Our Ref. : FSCA -SHS-2023-001

FIELD SAFETY NOTICE

FSCA- SHS-2023-001, OPMI LUMERA 300, inspect (repair if needed) the suspension arm

Fig. 1

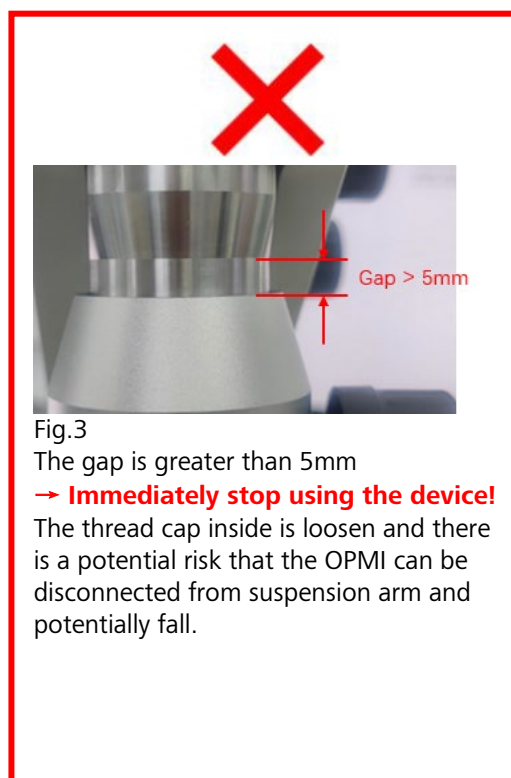
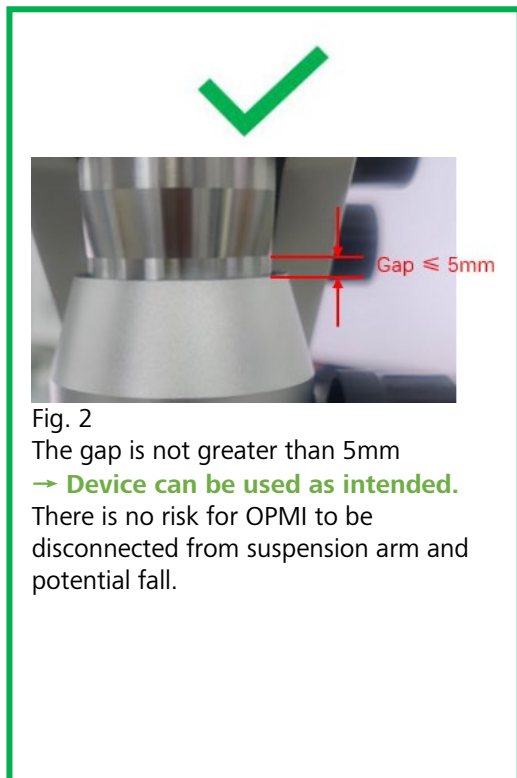
In certain devices there is a probability of specific screw missing during assembly. This screw is used to prevent one internal thread cap rotating which ensure the connection between suspension arm and the suspended components. The identified defect may lead to a potential risk.

The gap shown in Fig 1 indicates the fasten status of thread cap (not visible) which carries all load of suspension arm. If this gap is not in its nominal value, there is a risk of OPMI falls from suspension arm.

- Measure the gap shown in Fig. 1
If the gap is greater than 5mm, **please Immediately stop using the device!**
In this case the OPMI LUMERA 300 can no longer be used.
